Sunset Garden Senior Living Apartments

**SITE PLAN**

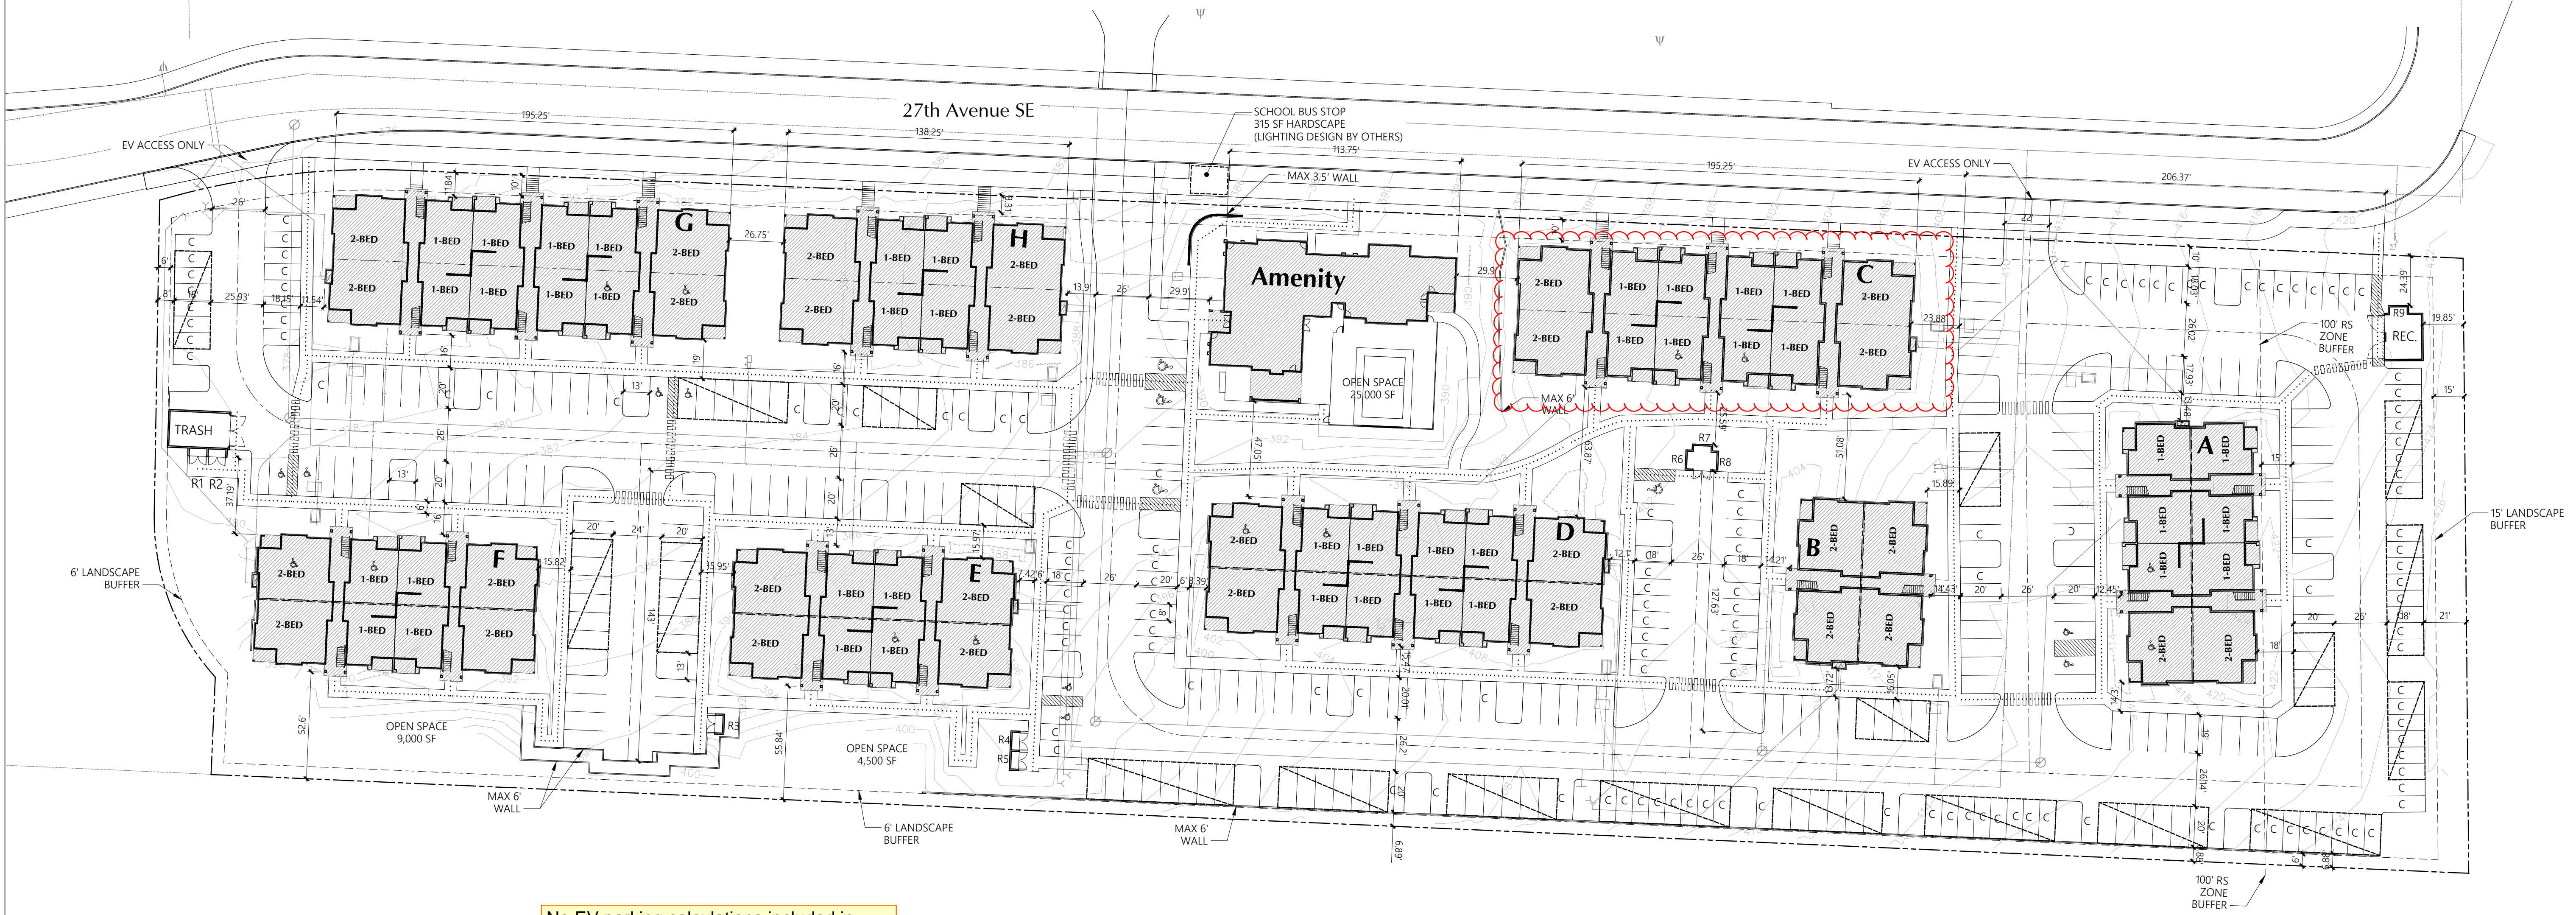
No EV parking calculations included in parking summary. Provide EV parking to meet Section 429 of the 2018 IBC WA Amendment.  
Page A2 - Site Plan

Incomplete site plan. Please refer to the CoP Site Plan Standards (available to download in the permitting portal). Revise the site plan to include items 1-3 and items A-X of the City's Site Plan Standards. Since the building permit cannot be issued until civil construction permit is issued first and the building plans must match the approved civil plans, please coordinate your final building permit submittal with the approval of the civil permit to avoid redundant or surplus building permit submittals and fees. [SITE PLAN, sheet A2]

Refer to the PRCNC20240278 corrections and address for all site plans associated with the Bradley Heights Apartments. [SITE PLAN, sheet A2]
